Volume V: Appendices M-O

United States Department of the Interior
Bureau of Land Management

Desert Sunlight Solar Farm Project California Desert Conservation Area Plan Amendment and Final Environmental Impact Statement

April 2011
CACA #48649

Image taken from base of Coxcombs - JoTr Wilderness

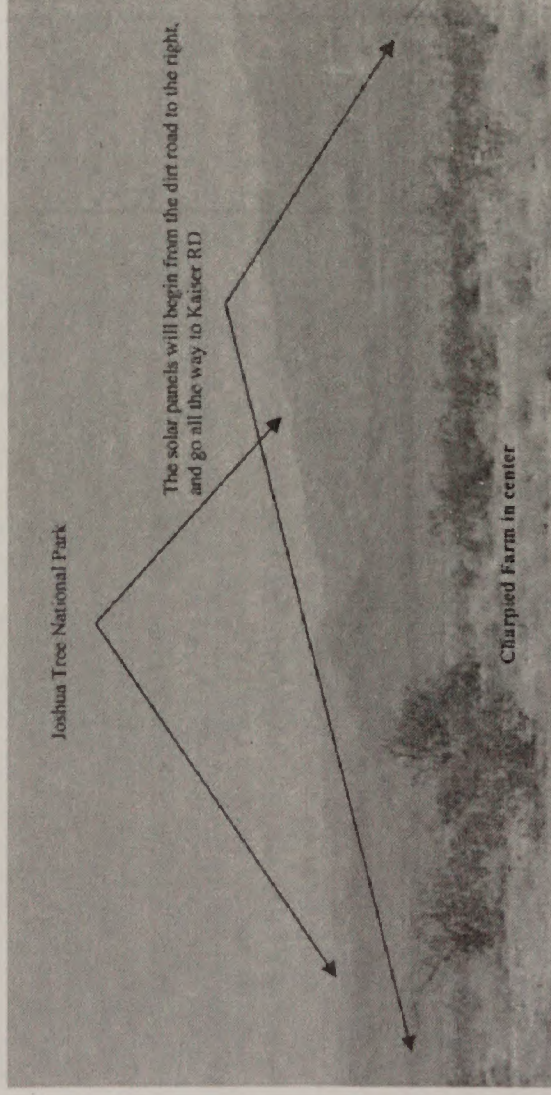
Key Observation Points ("KOP") that we viewed during the BLM meeting in Desert Center never even attempted to show the project to sensitive receptors. Not one image was taken from private property lines. Further, the private property owners in Section 16 would have to be blind not to see the mirrors. The Charpied's will not only see the panels, they will hear the constant hum of the transformers and have their eyes assaulted by transmission lines, and panels where Joshua Tree National Park Wilderness once painted the scenery. A visitor's wilderness experience in Joshua Tree National Park will be impugned.

Image taken from Project area to Charpied Farm

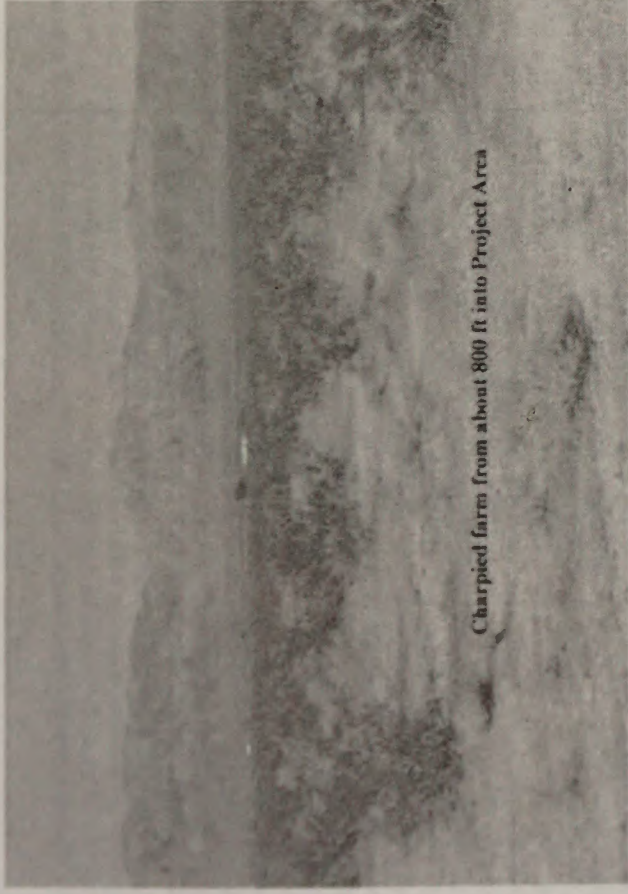
In 1994, we granted Eagle Crest Energy Company permission to access our property to drill three monitoring wells. Flow, drawdown, recovery rates were all calculated from 24-hour test pumps. During the time of the data collecting and preliminary analysis, Patti Croen, lead person for Greystone, and Mark E. Sydnor, Senior Hydrologists, both told us that the water necessary was not available. The study was to determine groundwater flow, availability, recovery, etc. The study included the 3 monitoring wells they drilled as well as the on-farm water well.

ATTACHMENT A

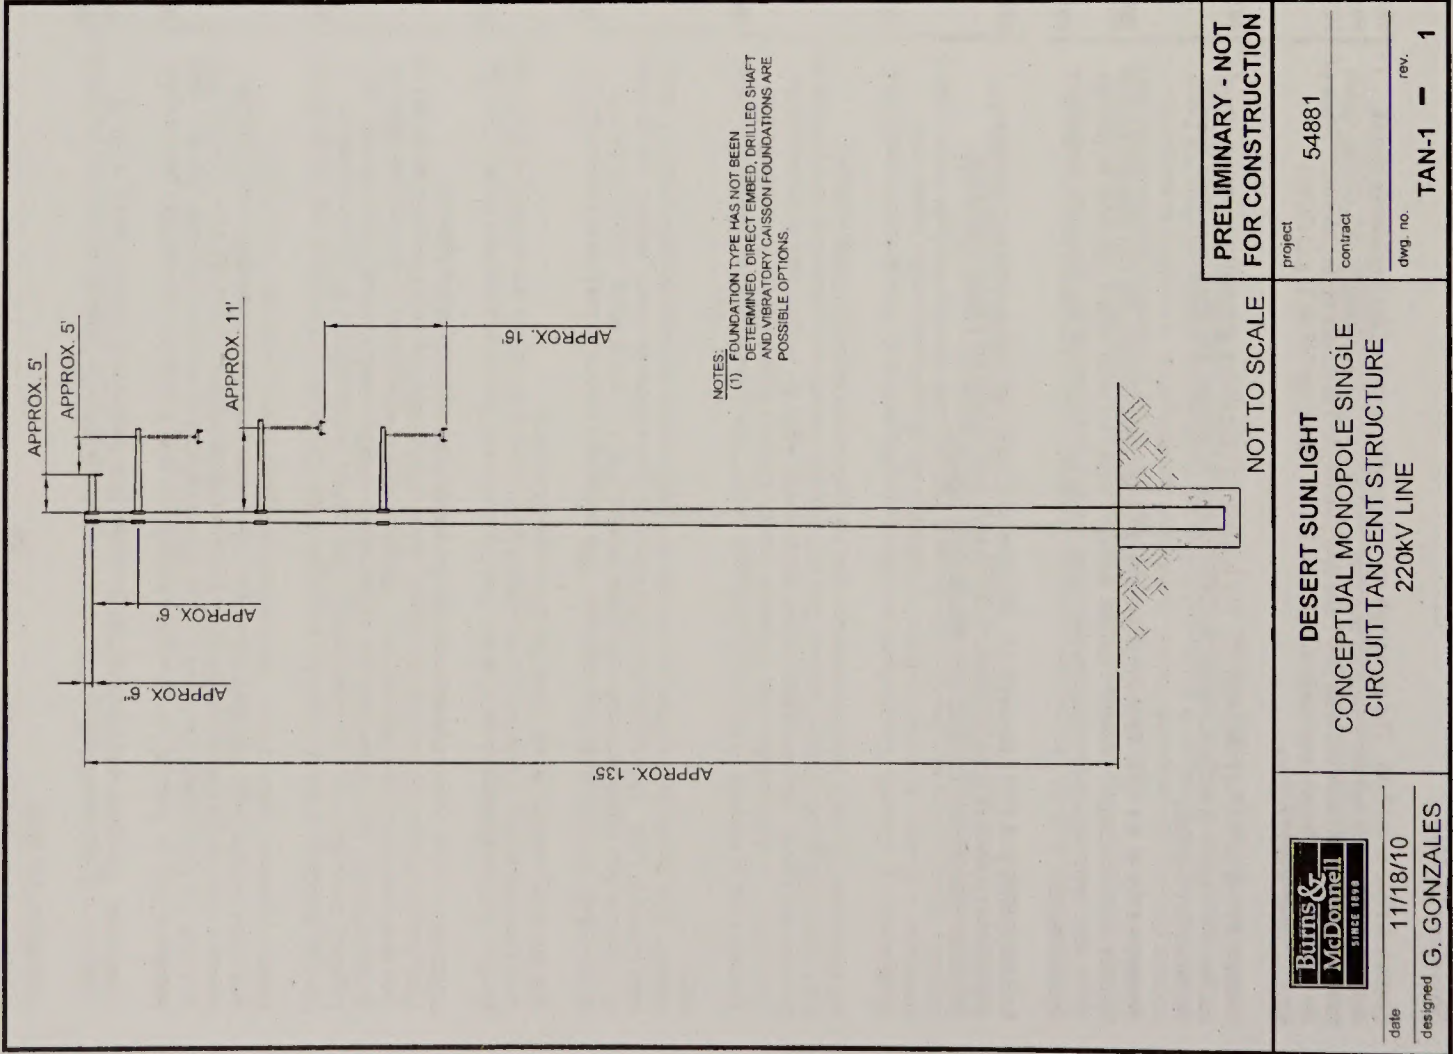
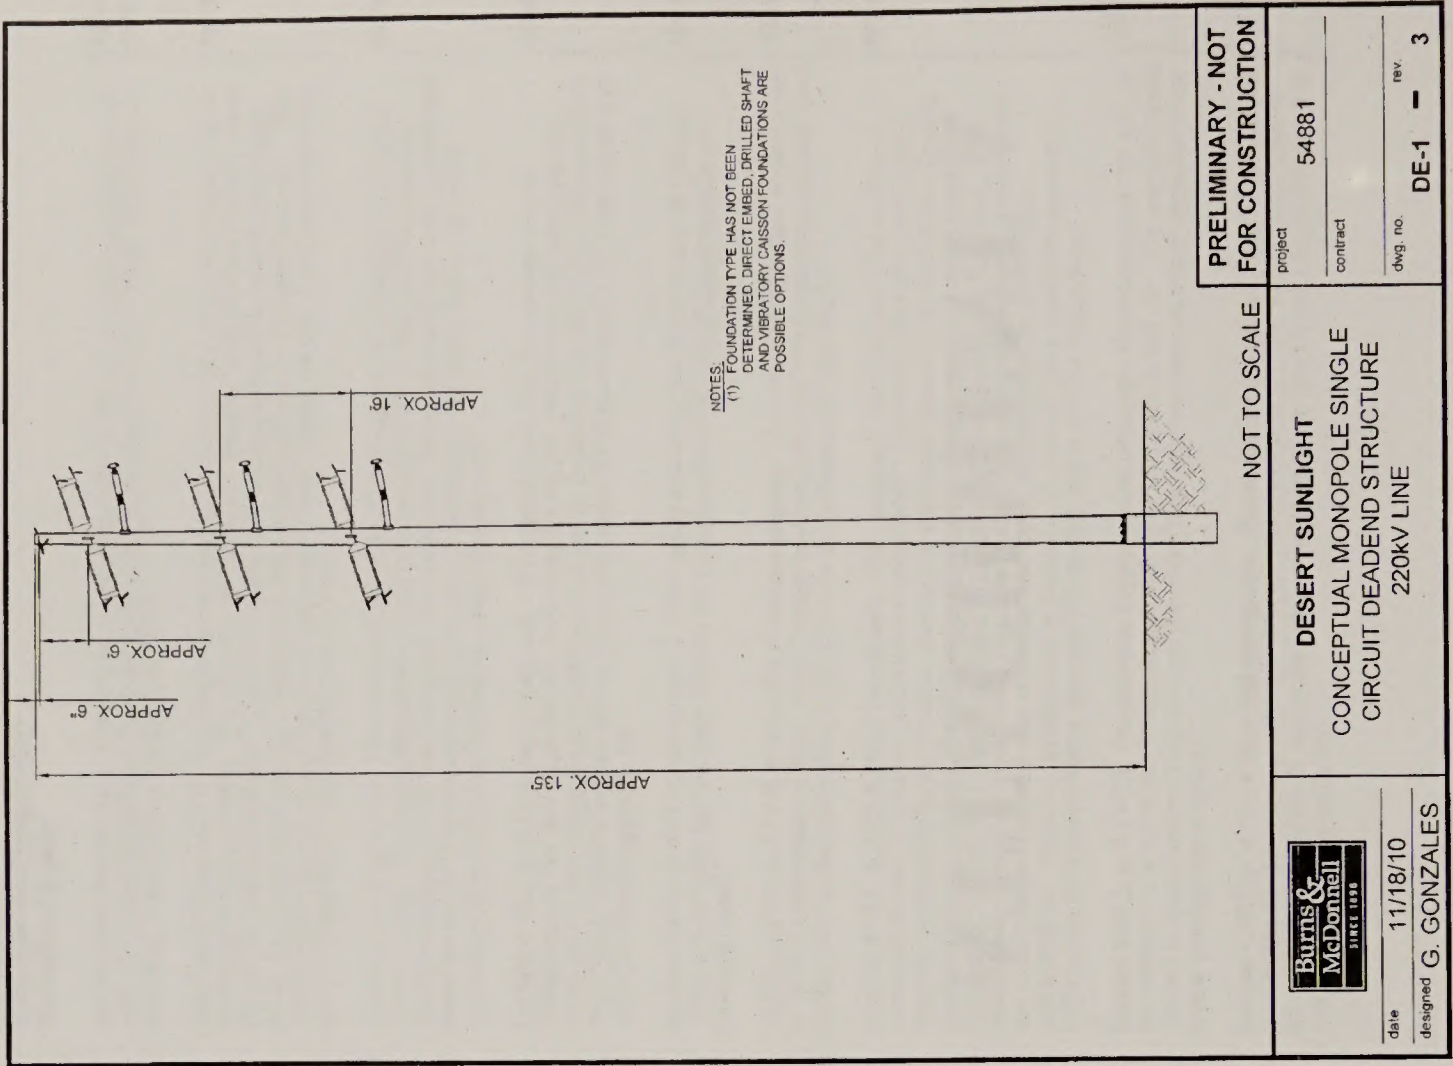
2.2.3, p. 2-18, second paragraph of “Transmission Line” section and Figures 2-10/2-11. First Solar has revised the design of the Gen-Tie poles from a delta to vertical configuration. We are therefore submitting revised figures to replace Figures 2-10 and 2-11, which are new figures TAN-1 and DE-1, respectively, and which are attached to this submittal of DEIS comments. This design change does not impact the height or footprint of the poles, the typical spacing between the pole structures, or the construction process for the Gen-Tie. The text in the second paragraph should be revised with the following:

“The Applicant plans to use steel monopoles for the Gen-Tie Line. Poles are expected to be approximately 135 feet tall. Typical 220-kV poles designed with a vertical configuration are shown in Figure 2-10 and Figure 2-11. Typical spacing between structures would be approximately 900 to 1,100 feet. Self-weathering steel would be used for the monopoles, which would blend with the surrounding mountains better than other potential finishes. Self-weathering steel is composed of a special alloy that forms an oxide, which prevents further rusting. The finish appears as a matte patina and is commonly used in environmentally sensitive areas where a shiny appearance would be undesirable.”

See attachment A (TAN-1 and DE-1 to replace Figures 2-10 and 2-11, respectively).
